Cross City Cycling – Ditton Lane and Links to East Cambridge

Proposed FDPC Response to Consultation for agreement FDPC meeting Feb 2nd

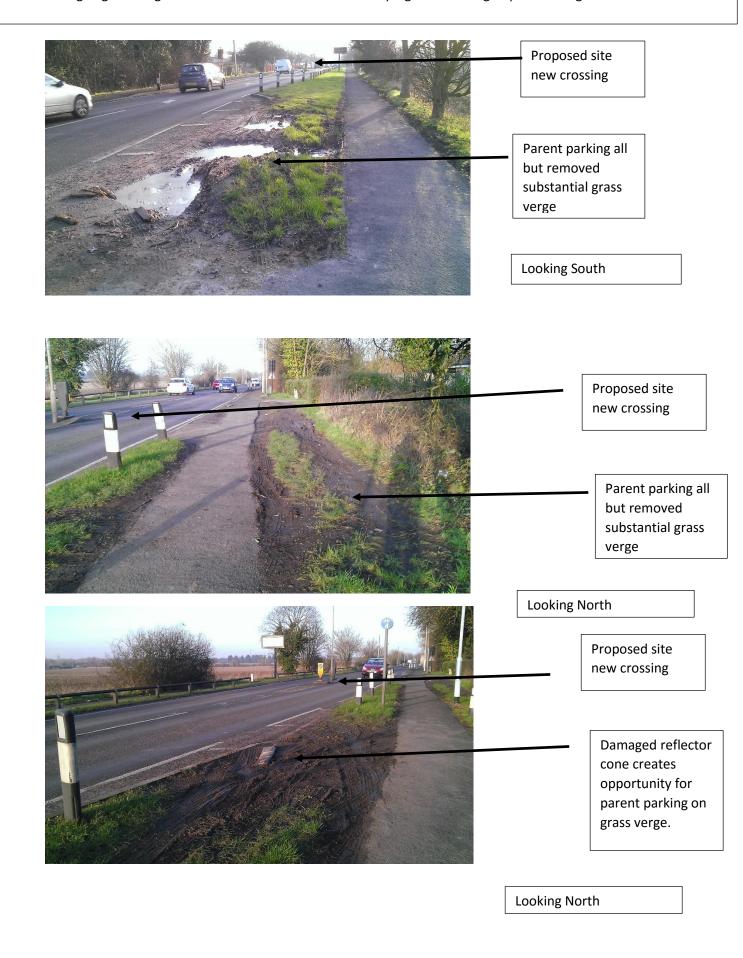
Please refer to Relevant Cross Sectional Maps attached.

1. Fen Ditton School Horningsea Rd (Ditton_4).pdf

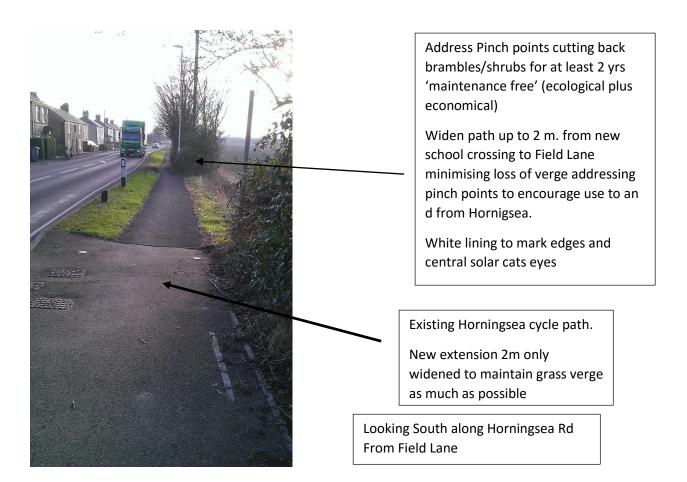
- 1. Make good grass verges/reinstate verges damaged by cars along length of Horningsea Rd. to Field Lane both sides of Rd.
- 2. Install additional knee rails to protect grass verges from 'parent parking' from new crossing on west side travelling North for some agreed distance towards Field Lane and identified risk area post installation of new crossing East side Horningsea Rd

- 3. Widen path from proposed new school crossing up to 2 m. travelling north to Field Lane to meet existing cycle /footpath minimising loss of roadside verge paying particular attention to pinch points (all to encourage usage to and from school catchment Horningsea + public usage)

- 4. To mark width of path with white lines as per existing Horningsea cycle path (some sharp edges to path and ditch running alongside) plus solar 'cat eyes' as per Wadloes footpath

- 5. Crown lift trees along length of Horningsea Rd to Field Lane to balance tress, improve specimens, encourage vertical growth minimising maintenance requirements longer term to keep path clear of overgrowth. Cut shrubs/brambles back along length of Horningsea Rd to allow min of 2 years growth before further cutting back required (ecological and economical).
